<p>FLORIDA'S TURNPIKE ENTERPRISE (FTE) Construction Engineer: Pete Nissen, P.E. Assistant Construction Engineer: Bill Sears, P.E. FDOT Design Project Manager: William Sloup, P.E. GEC Design Project Manager: Terry Miller, P.E. Construction Project Manager: Ken Hudson</p> <p>CCEI NEW MILLENNIUM ENGINEERING, INC. (NME) Sr. Project Engineer: Gus Quesada, P.E. Project Administrator: Sergio Ambros</p> <p>CONTRACTOR COMMUNITY ASPHALT CORPORATION (CAC) Project Manager: Vernon Walker Project Manager: Aryail M. Gomez</p> <p>ENGINEER OF RECORD MOFFATT & NICHOL (M&N) EOR: Richard Rocktoff, P.E. Project Manager: Jeff Messenger, P.E.</p>	<p>PERFORMANCE MEASURES:</p> <p>Notice to Proceed Date: 06/06/13 Construction Start Date: 07/08/13 Completion Date: 05/19/14 Original Contract Time: 270 days <u>Approved Time Extensions:</u> Weather/Holidays: 46 days Supplemental Agreements: 0 days Final Contract Time: 316 days % Overrun Orig. Contract Time: 0%</p> <p>Original Contract Amount: \$6,589,153.50 Final Contract Amount: \$6,665,935.50 % Overrun Contract Amount 1.17%</p> <p>Final CPPR: 91</p>

<p>PROJECT DESCRIPTION: The Improvements under this Contract consist of milling and resurfacing with design cr

211 Painted Pavement Markings –

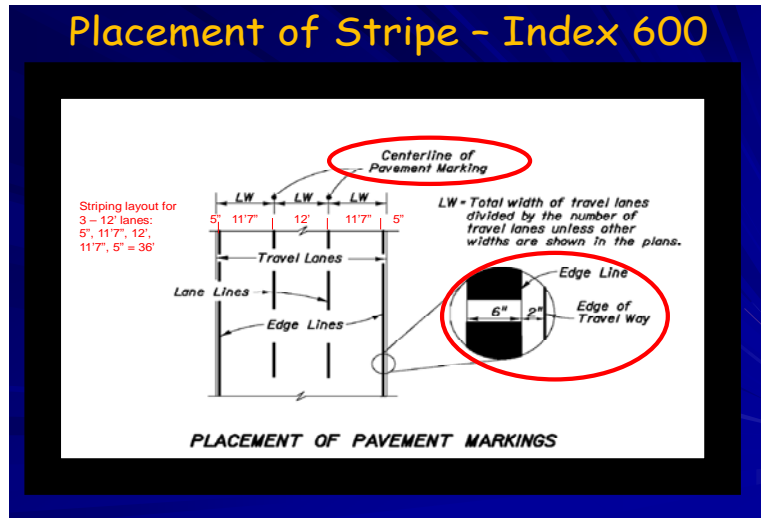
The shoulder width throughout the project varied from 10' standard (+/-) 0"-8", which made it difficult to maintain the standard detail. This was even more of a challenge when we approached the bridges as you can see from the illustrations below as well as the beginning and ending of the project limits.

Summary and Recommendation: for the bridge approaches we recommend to create a typical detail that tapers the FC to meet the existing bridge edge line configuration. This way we keep the edge line completely on the FC and maintain compliance with the index requirements. This issue was not as prevalent on the main line; however, there are cases where the edge line does not have the prescribed 2" clearances from the EOP.

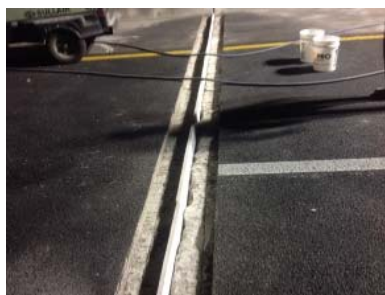
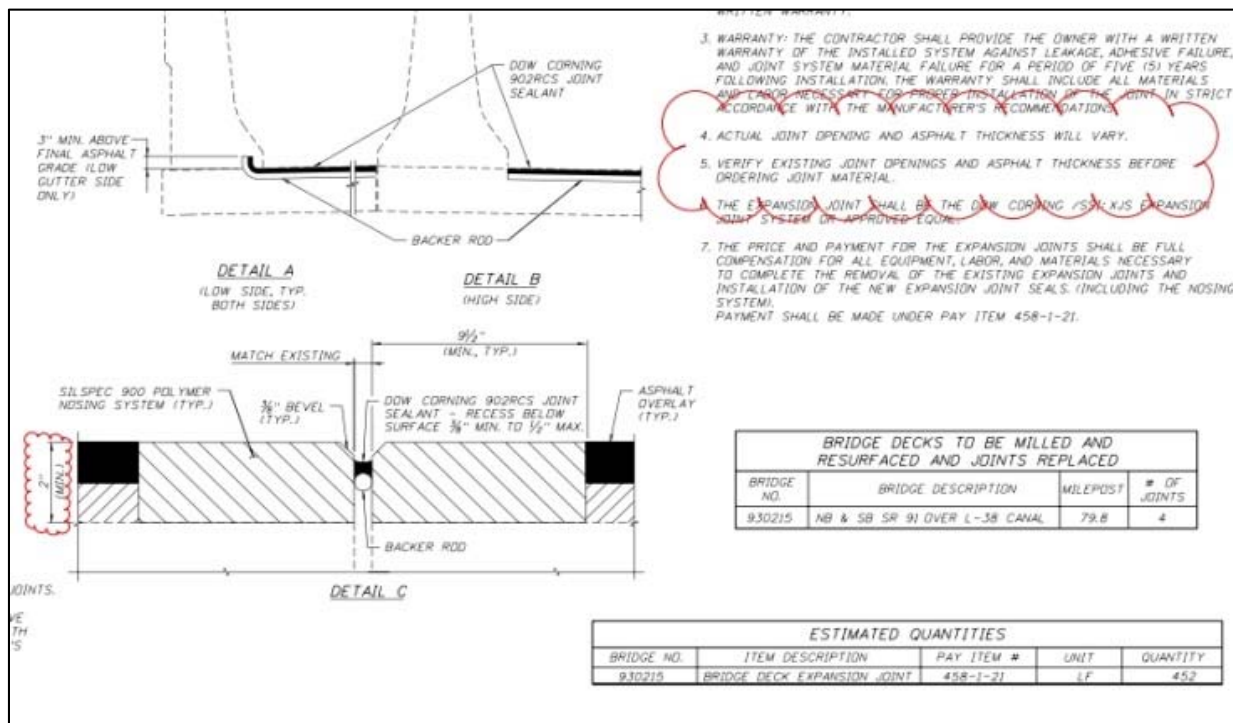
Pay Item: 458-1-21 Bridge Deck Expansion Joint (Plan Quantity) – The joint installer is claiming unforeseen conditions based on the significant difference between the theoretical joint thicknesses to that of the actual field condition. Although the plan sheet requires that the contractor verify the thickness prior to initiating the operation, it does not provide for compensation if there is an overrun based on thickness. The contractor assumed a theoretical thickness of 2" and applied 1.5" overbuild after milling, 3/4" FC, and deduced that the final thickness would be 2.75"; however, the actual thickness for the joint was between 3.5" – 4".

Summary and Recommendation: NME has discussed this issue with several bridge design engineers and it's a common occurrence on rehabilitation projects; that the bridge design engineers place the 2" (min) on the detail simply to address the design criteria, not to be used as a threshold for estimating labor/materials needed. The notes on the plan do not address estimating for costing the item, they are more to the operation's logistics so that the contractor doesn't start the work without having the proper materials on hand. We recommend that several cores be taken during the design phase and the results provided on the plans for estimating purposes.

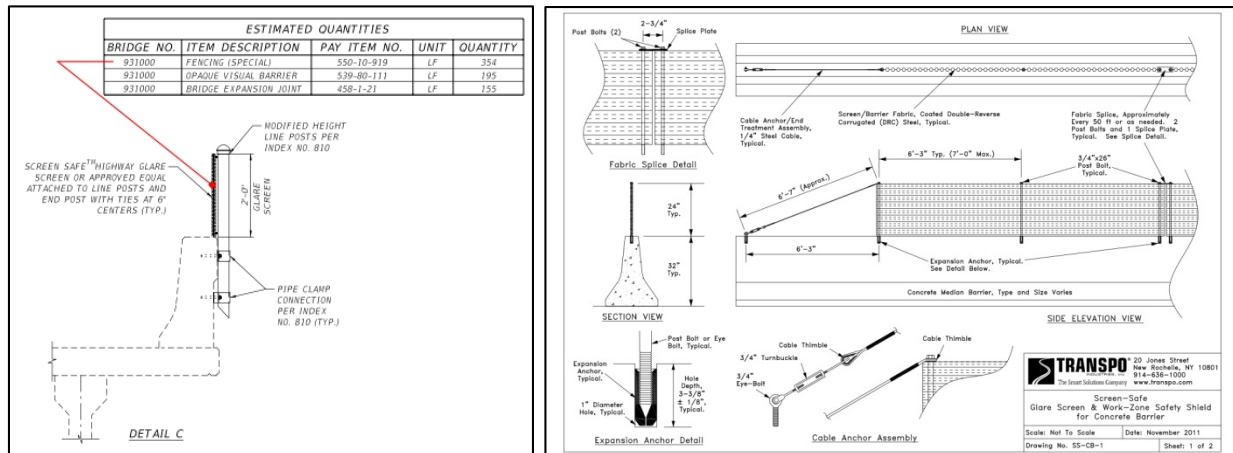
Pay Item: 550-10-919 Fencing (Special) – We encountered an issue where the glare screen installer did not properly interpret the intent of the plan detail (Detail C, left) and assumed that the manufacturer’s recommended anchoring detail (right) would supersede the Plan detail. This was cause for delays and it is currently a pending claim where the subcontractor feels that the anchoring should be the manufacturer recommended rather than the one prescribed by the plan detail.

Summary and Recommendation: Although we feel that the Detail “C” is clear in relating the intent of the EOR, the fact that we are veering from a manufacturer’s recommended installation detail is not good practice. We recommend that if sole sourcing a product, the EOR should investigate all aspects of the product’s working criteria and include them as part of either a pay item note or TSP. The final product required some creative thinking on the part of the subcontractor, which yielded an acceptable product.
